Planning and Zoning Commission - Regular Meeting

July 16, 2026 - 5:30 PM

Development Review Committee Comments |
07/01/26
Case: SD#26-021
Preliminary Plat of Munoz Tract

WRITTEN STATEMENT OF CONDITIONS

PRELIMINARY PLAT

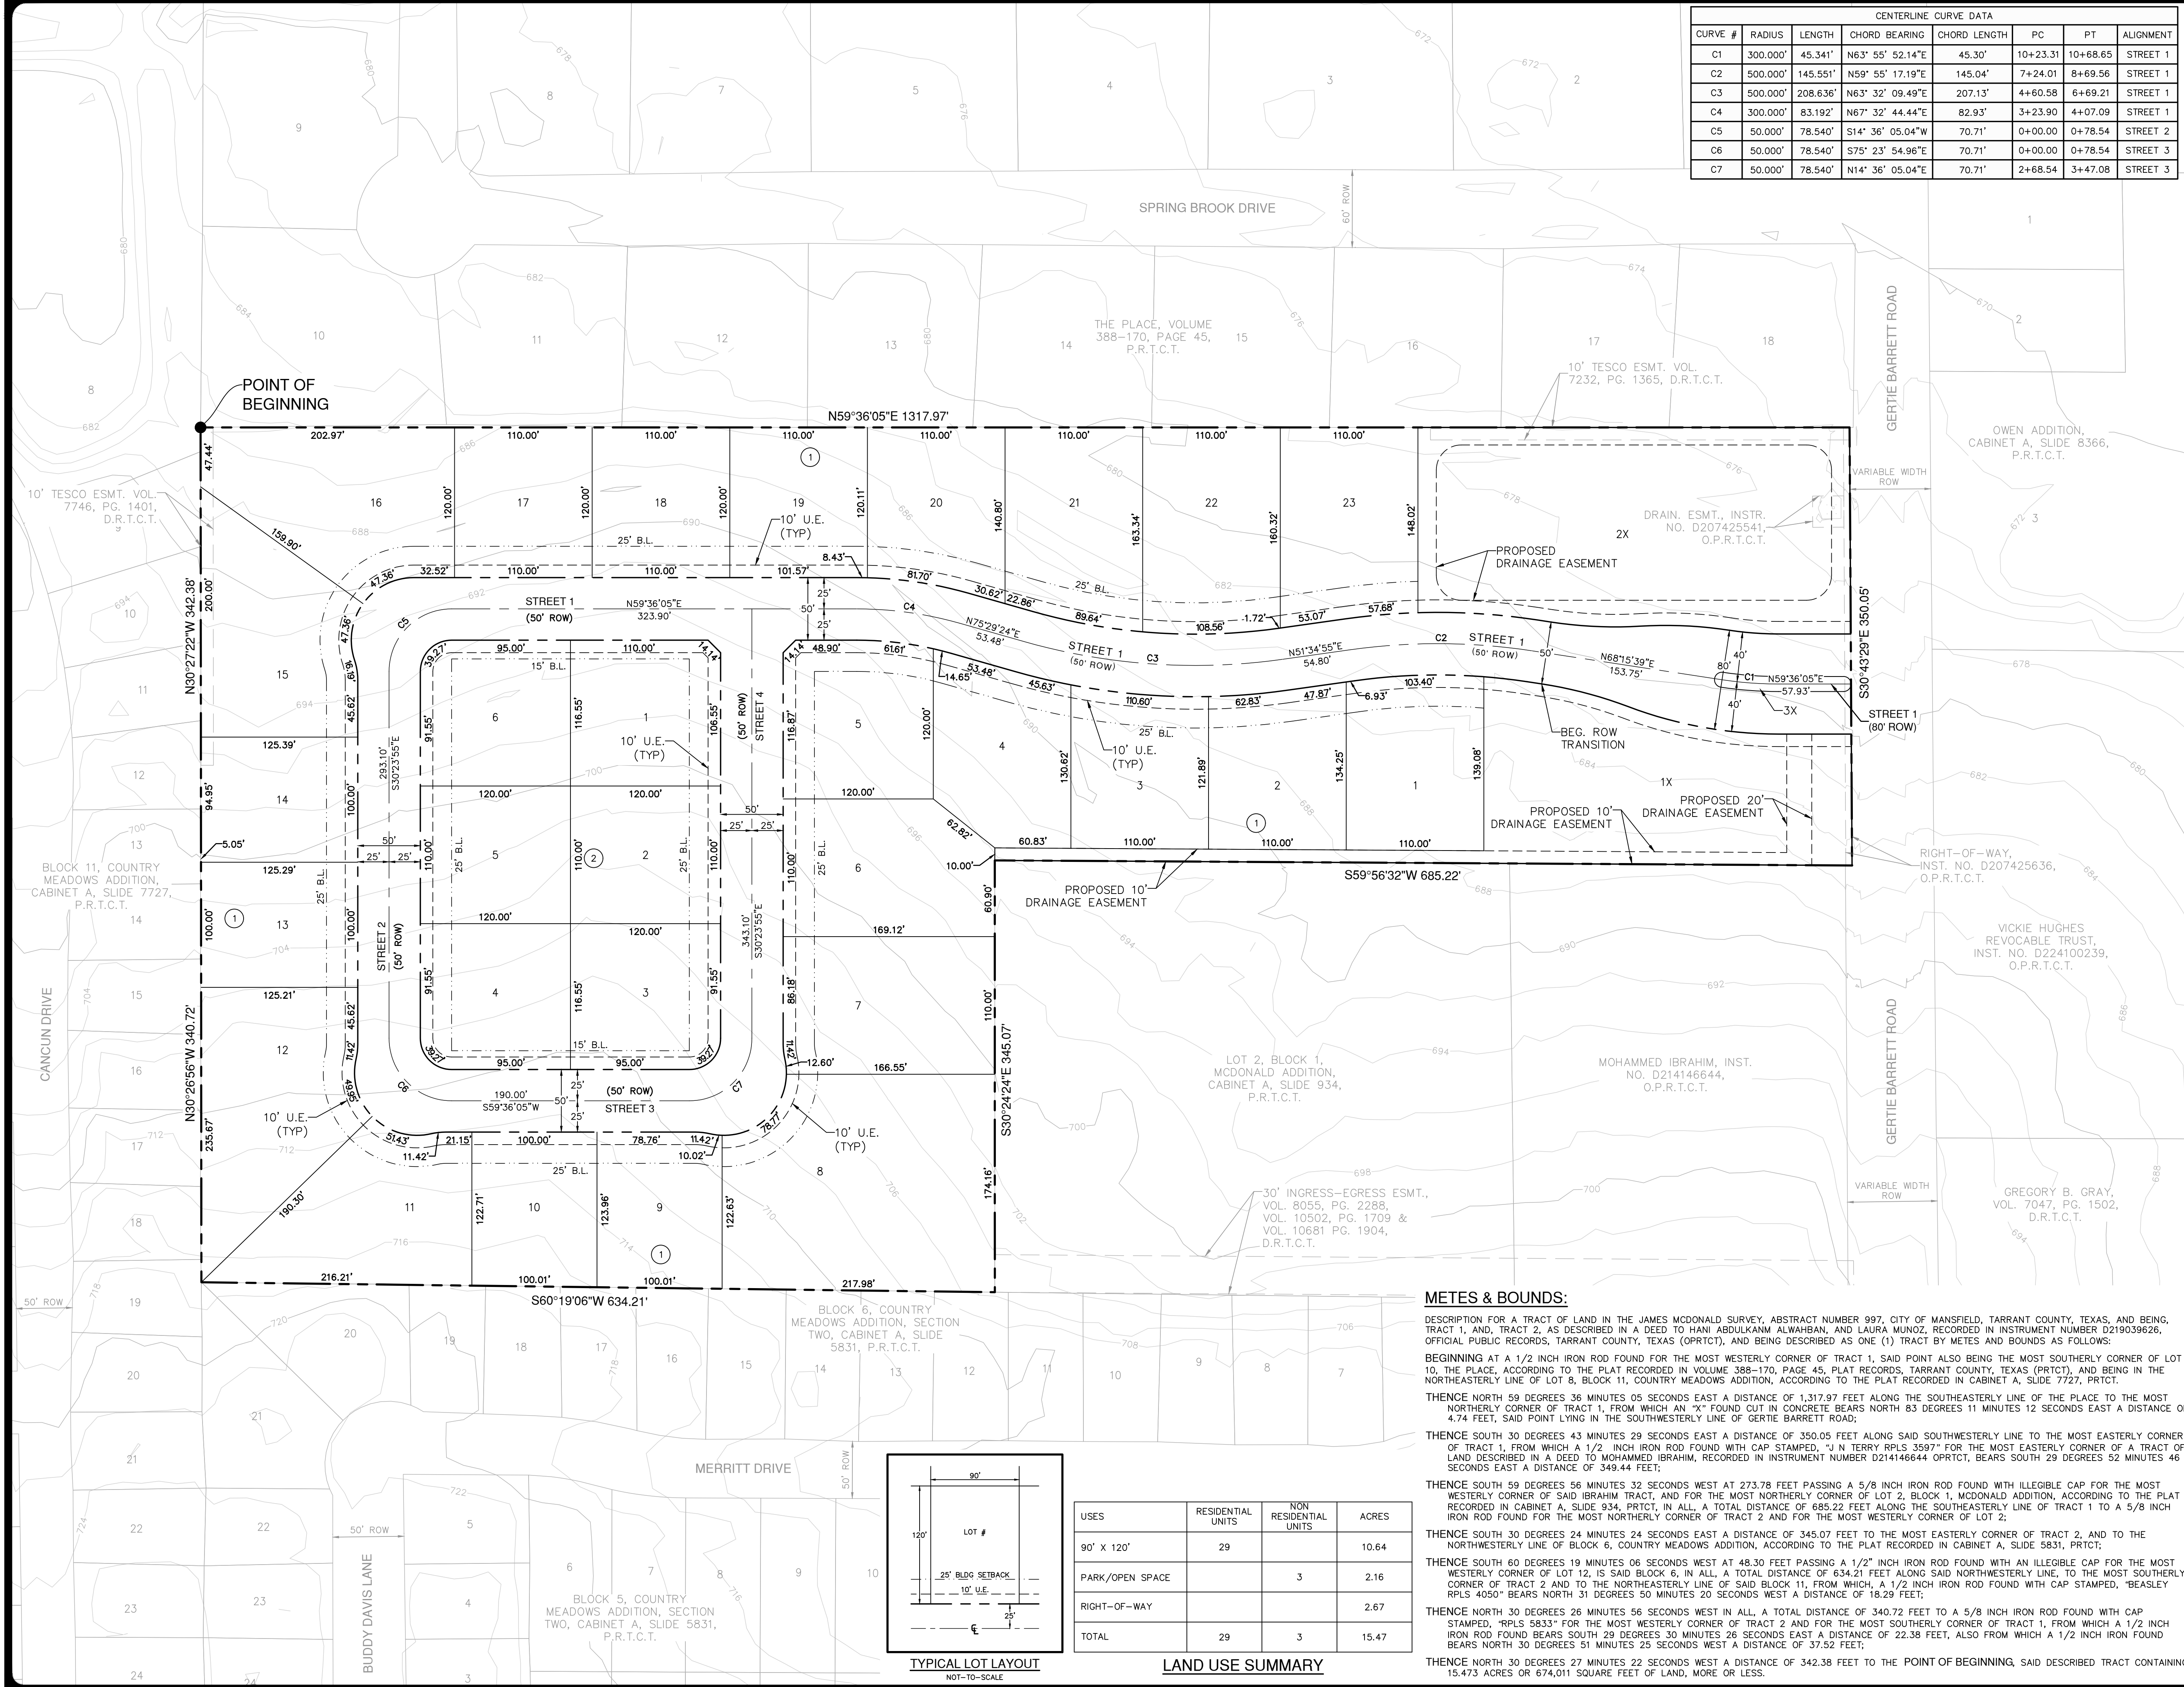
1. When platted, this property will no longer be a tract. Propose a subdivision name that does not include "Tract" (i.e., Munoz Addition, etc.). ***Subdivision Control Ordinance §2.02(C) (Requirements for subdivision names)***
2. Remove the Page 1 of 1 label under the title block. It is not required on a single-sheet plat. ***Subdivision Control Ordinance §2.02(F) (Requirements for multi-sheet plats)***
3. Add the case number (SD#26-021) under the title block. ***Subdivision Control Ordinance §2.02(G)(1) (Requirements for case numbers)***
4. Revise the title block to match the City's standard format ***Subdivision Control Ordinance §2.02(G)(5) (Requirements for title blocks):***

5. Add the engineer/surveyor's email address to the surveyor information on the plat. ***Subdivision Control Ordinance §2.02(G)(5) (Requirements for surveyor information)***
6. Show and label all existing and proposed easements on or adjacent to the subdivision as to type, size, and deed or plat record information. These are utility easements on the lots adjacent to this property in the Country Meadow and The Place subdivisions. ***Subdivision Control Ordinance §2.02(G)(11) (Requirements for easements)***
7. Lots and blocks must be labeled with numbers in consecutive order, including X lots. On Block 1, revise the lot numbers to be in order (i.e., 1X, 2, 3, 4...25X). Revise Lot 3X to be Lot 1X, Block 3. ***Subdivision Control Ordinance §2.02(G)(13) (Requirements for lot and block numbers)***

8. Show the square footage of each lot on the graphic or in a table. The area of Lot 3X was not shown in the Open Space Lots table. Be sure to revise the lot numbers of the open space lots in the table. **Subdivision Control Ordinance §2.02(G)(15) (Requirements for lot square footage)**
9. Use a solid line to represent the property lines of Lots 1X and 2X along Gertie Barrett Road where the right-of-way dedication was made by Instrument No. D207425636. The dashed line resembles an easement. **Subdivision Control Ordinance §2.02(G)(18) (Requirements for boundary lines)**

10. Show the full and centerline dimensions of all streets, including Gertie Barrett Road. **Subdivision Control Ordinance §2.02(G)(18) (Requirements for existing and proposed rights-of-way)**

11. Proposed street names cannot have the same spelling or be pronounced similarly to the name of any other street located within the City or the City's extraterritorial jurisdiction, unless a proposed street is a continuation of an existing street. Provide a list of street names for this development. **Subdivision Control Ordinance §2.02(G)(19) (Requirements for street names)**

12. Remove the Typical Lot Layout graphic from the plat. It is not required. **Subdivision Control Ordinance §2.03(C) (Requirements for preliminary plats)**

13. Label the designation of the existing zoning of land within the subdivision and properties adjacent to the subdivision on the graphic. **Subdivision Control Ordinance §2.03(C)(2) (Requirements for zoning to be shown on preliminary plats)**

- a. Provide two GPS corners on the plat at opposite ends of the subdivision. These are missing from the plat.

- b. The CAD file does NOT align properly with the City's GIS. Provide a DWG using NAD 83, grid coordinates.
15. Add a note stating: A mandatory homeowners association will be responsible for the maintenance of the open space lots and the enhanced entry way features, including but not limited to medians, landscaping, any non-standard pavement, and the enhanced masonry walls with signage. ***Subdivision Control Ordinance §10(N) (Maintenance responsibility)***

16. The following comments are related to tree preservation. ***Subdivision Control Ordinance §2.03(D)(3) (Requirements for tree preservation plans)***

- a. Provide a tree survey with the location, species and dbh of trees. The removal plan does not offer enough data to evaluate compliance with Chapter 99. Preservation of trees shall be evaluated with due regard to aesthetics and other physical characteristics (e.g., topography, view corridor, utilities, access) of the site. This evaluation should be made prior to the design and layout of the proposed improvements such that the environment suggests the design. The city deems it necessary that a developer consult with the Landscape Administrator as early in the site search, acquisition, and planning process as possible to minimize negative impacts on the development. Clear cutting (The removal of all of the trees or a significant majority of the trees within an area) is prohibited. Tree replacement is not meant to supplant good site planning and allow the indiscriminate clearing of property without considering alternative designs and solutions that could reasonably accommodate the same activity or land use.

- b. Until we have approved final plans, there are no deductible areas or trees.
 - c. Without knowing what trees or sizes of trees are out there, it is hard to evaluate, but based on the information provided, more tree preservation will be required.

17. The entirety of Lot 2X should be a drainage easement. ***§2.02(G)(11) (Requirements for easements)***
18. Include Conditions of Drainage Acceptance on plat. ***§2.02(G)(11) (Requirements for easements)***

19. Remove the word "Proposed" from the dedicated easement. ***§2.02(G)(11) (Requirements for easements)***
20. The runoff coefficient for residential should be 0.6. ***§2.03(D)(1) (Requirements for a preliminary drainage study)***

21. Regarding Block 1, Lots 16-22: Please clarify grading and drainage will work. Post drainage runoff cannot drain onto adjacent properties. You may need to provide a

private drainage easement or a retaining wall to ensure stormwater is properly conveyed to the detention pond. **§2.03(D)(1) (Requirements for a preliminary drainage study)**

22. Provide some additional clarification regarding the overall drainage for this project. **§2.03(D)(1) (Requirements for a preliminary drainage study)**

23. Explain why the property includes part of the existing right-of-way. **§2.02(G)(18) (Requirements for existing and proposed rights-of-way)**

24. The median is currently shown within the right-of-way outside of the property boundaries. Revise the plans to pull the median back so it is no longer located in the right-of-way. **§2.02(G)(18) (Requirements for existing and proposed rights-of-way)**

25. Any proposed subdivision must be connected to the existing street system through at least two separate street connections. **Subdivision Control Ordinance §10(B)(3) (Requirements for two points of street connection)**

26. Corner residential lots must have a minimum width 15 feet greater than the adjacent lot. The following lots do not comply with this requirement: Lot 5, Block 1, and Lots 1, 3, 4, and 6, Block 2. **Subdivision Control Ordinance §10(M)(6) (Requirements for corner lots)**

27. Cul-de-sacs cannot exceed 600 feet in length. Street 1 does not meet this requirement. ***Subdivision Control Ordinance §10(B)(7) (Cul-de-sac length)***

As the adjacent properties are already developed, a variance may be requested for relief from this requirement. Submit a letter of request.

Based on the size of the lots, a variance may be requested for relief from this requirement. Submit a letter of request.

This is not a traditional cul-de-sac with a turnaround, and a variance may be requested for relief from this requirement. Submit a letter of request.

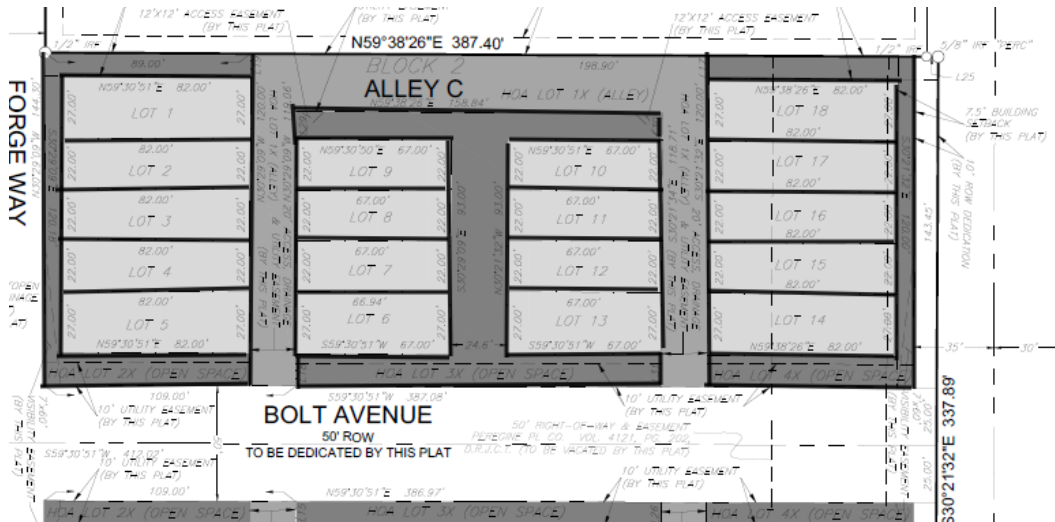
1. Add the case number (SD#26-004) under the title block. ***Subdivision Control Ordinance §2.02(G)(1) (Requirements for case numbers)***
2. Remove the gray shading from all lots, alleys, and open space lots, and delineate these areas using continuous linework throughout the development to ensure clarity and consistency on the plan. ***Subdivision Control Ordinance §2.02(G)(17) and 3.15 (D) (Requirements for linework)*** Example:

3. Remove 'Alley A, B, C, D, & E' names throughout the plat and list as lot and block since the properties will be addressed with the ROW street names. Label as X lots and update the title block. ***Subdivision Control Ordinance §2.02(G)(19) (Requirements for street names)***
4. Water meters and public fire hydrants must be located within a dedicated utility easement.
5. The public sidewalk must be placed within the right-of-way or a dedicated sidewalk easement.
6. If public improvements associated with this plat exceed \$25,000.00, surety will be required for those improvements prior to filing the plat.
